City of West Allis

Plan Commission

2. [25-0265](#) Site, Landscaping, and Architectural Design Review for F Street 92, LLC, a proposed 5+ Unit Dwelling use, at 1405 S. 92nd St. (Tax Key No. 450-0502-000)

DATE: 7/17/2025
 TO: City of West Allis
 CC: Ryan Neidinger – RINKA
 PROJECT: 92nd and Greenfield Multifamily
 PROJECT NO.: 24101
 RE: Responses to City Staff Plan Commission Comments

1 ARCHITECTURAL SITE PLAN
1" = 30'-0"

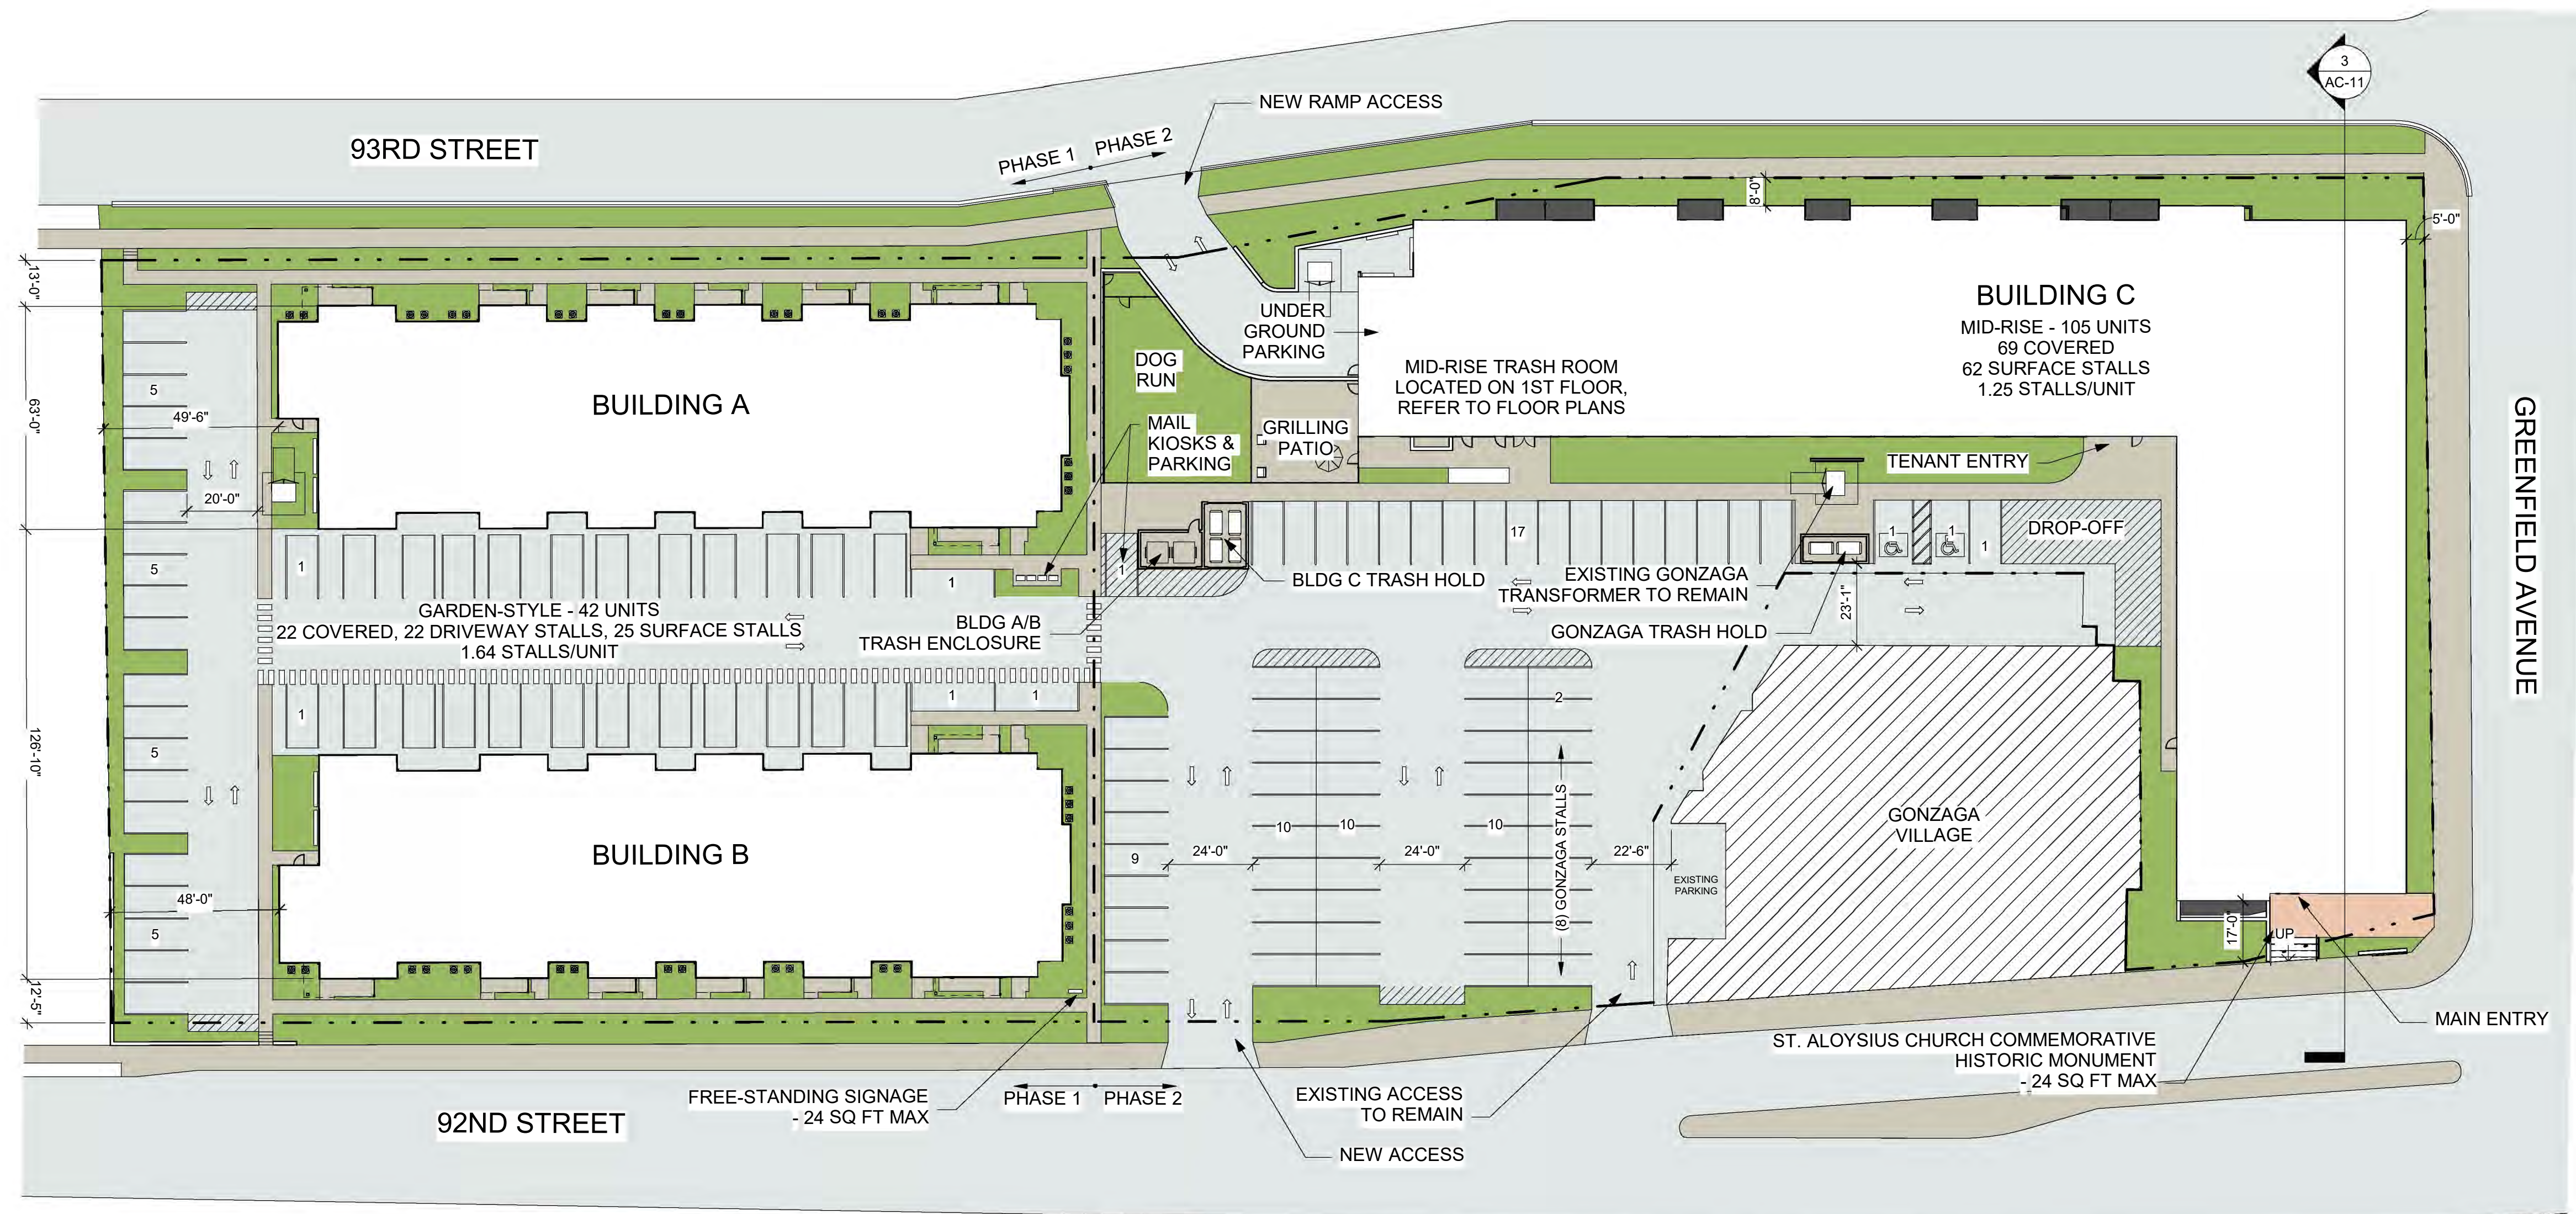
3. Garden Apartments - Density of the overall development has been reduced by 8 units. 69 parking stalls are provided off-street. This includes 20 new parking spaces that have been added on the south end of the site. While the parking ratio doesn't exceed the parking maximum of the zoning code, our preference would be for more units vs more parking. Please provide more info on striking the density vs parking balance in the decision to reduce the number of units.
RINKA Response: Correct. Between the initial site plan and the plan commission submittal, the overall unit count was reduced by 8 garden style (GS) units. This change was in response to feedback from the leasing team, who indicated that larger GS units with attached garages are far more favorable to prospective renters. By reducing the units, and incorporating more attached garages, we were able to increase the ratio of attached garages, better-meeting market needs. Note that since the submission, the overall unit count has increased by 4 mid-rise (MR) units, totaling total 147. This helps with density across the site, while also considering parking ratio between building types. Refer to attached revised plan excerpts.

30. Please clarify driveway entrance directionals. Need confirmation of whether each driveway will be a right-in right-out or multi-directional.

RINKA Response: Refer to architectural site plan for intended directionals.

SITE PLAN

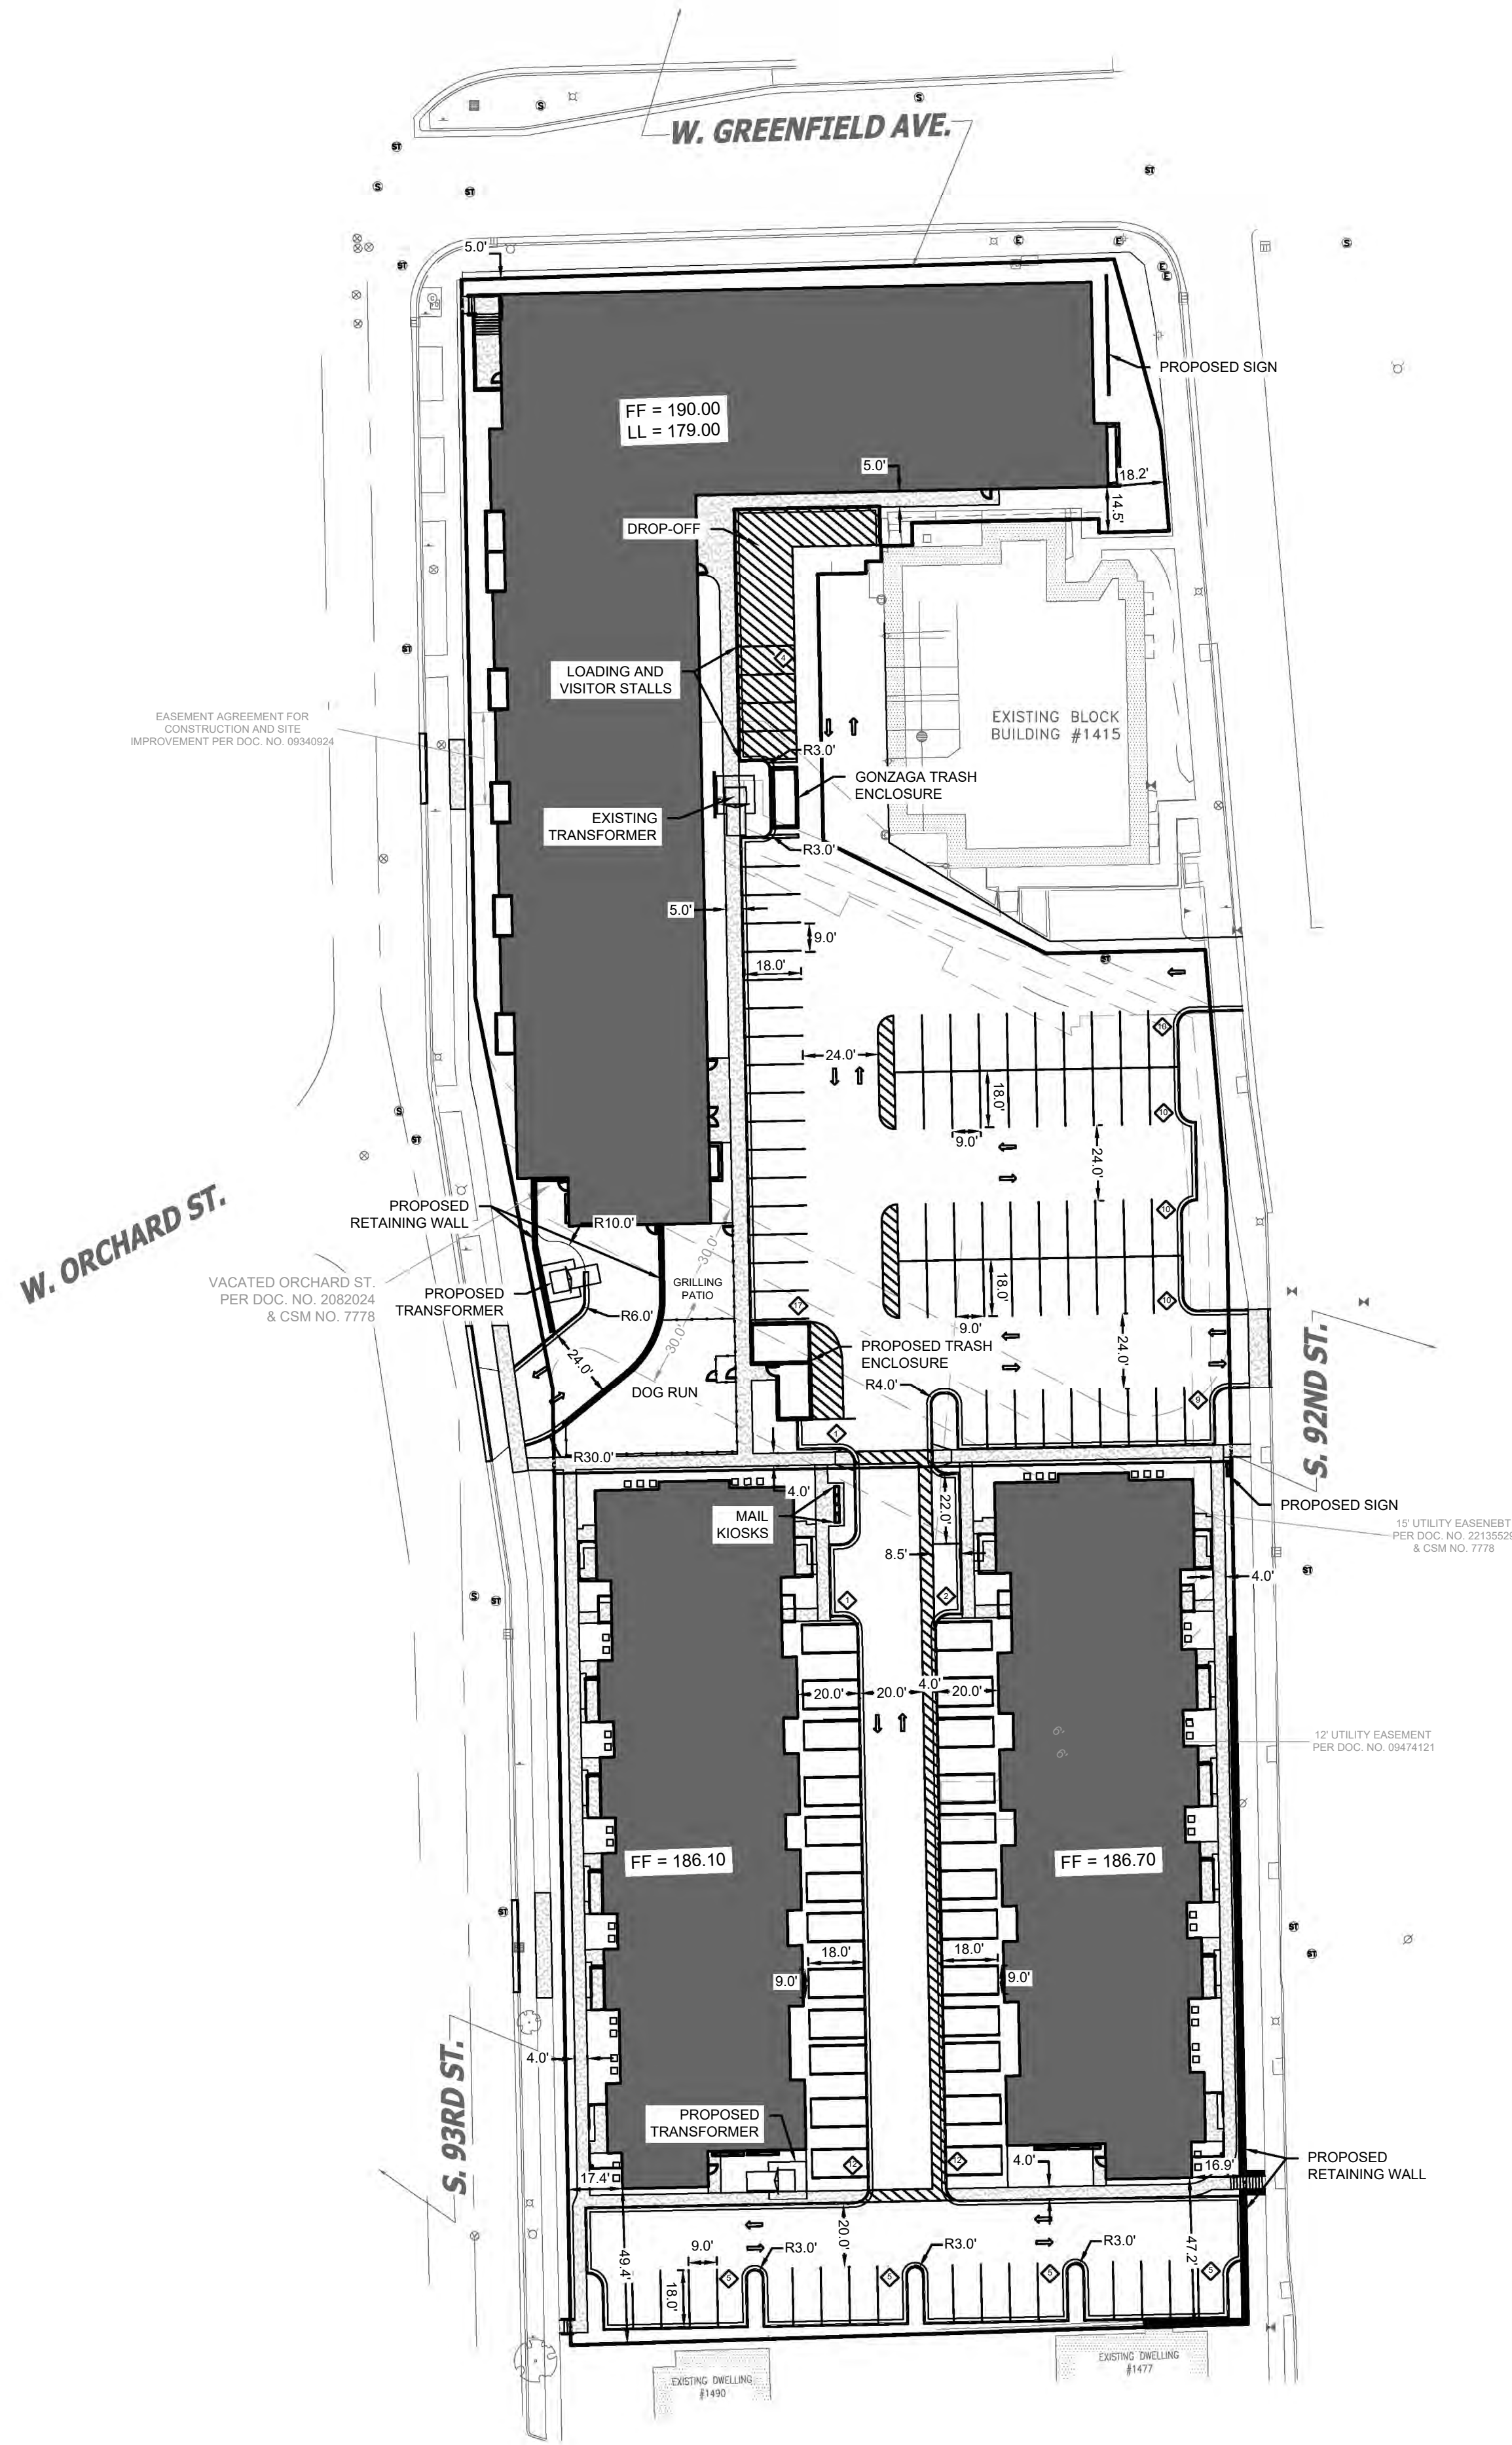
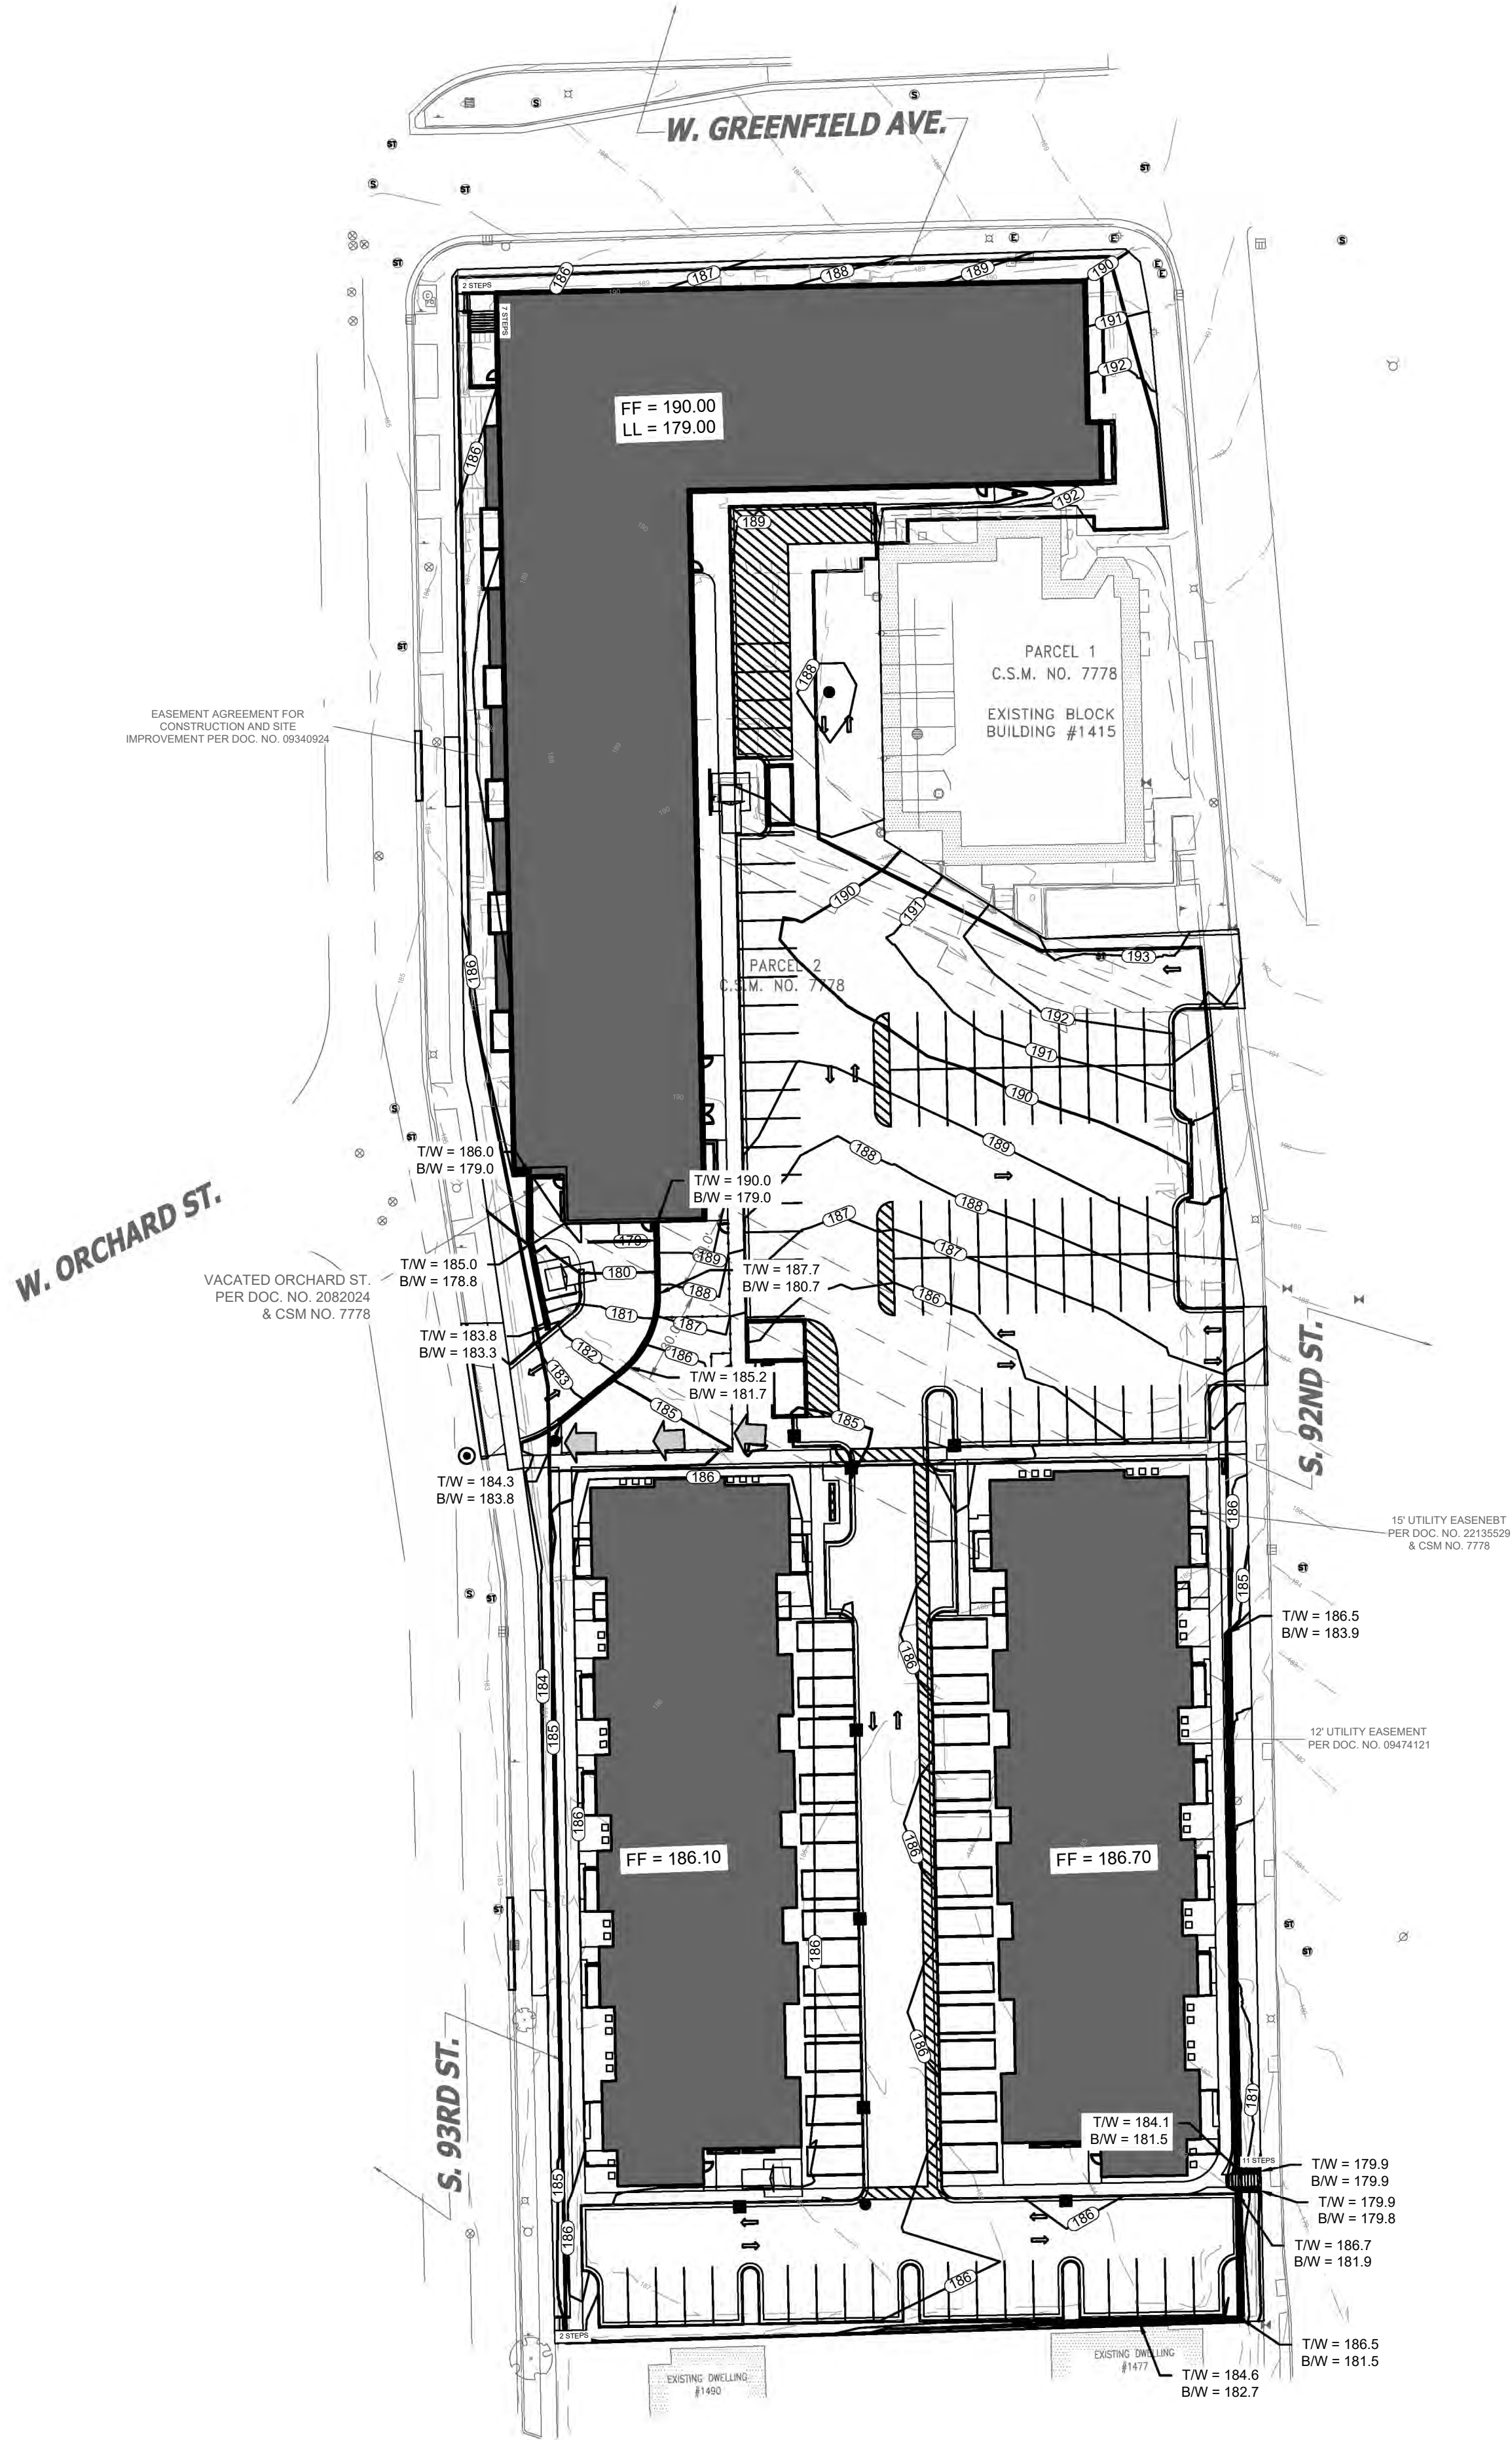
4. Will take a closer look at landscaping considerations on site. On the south end staff would recommend species to buffer parking from residences to the south.
RINKA Response: Refer to response #5.

5. South end of site - Existing currently is a chain link fence, perhaps a more decorative opaque fencing option could be utilized to provide more privacy. Ensure proposed landscaping will screen parking lot and lines of sight.

RINKA Response: A combination of screening landscape and/or 5' cedar fence is being considered along the southern property line.
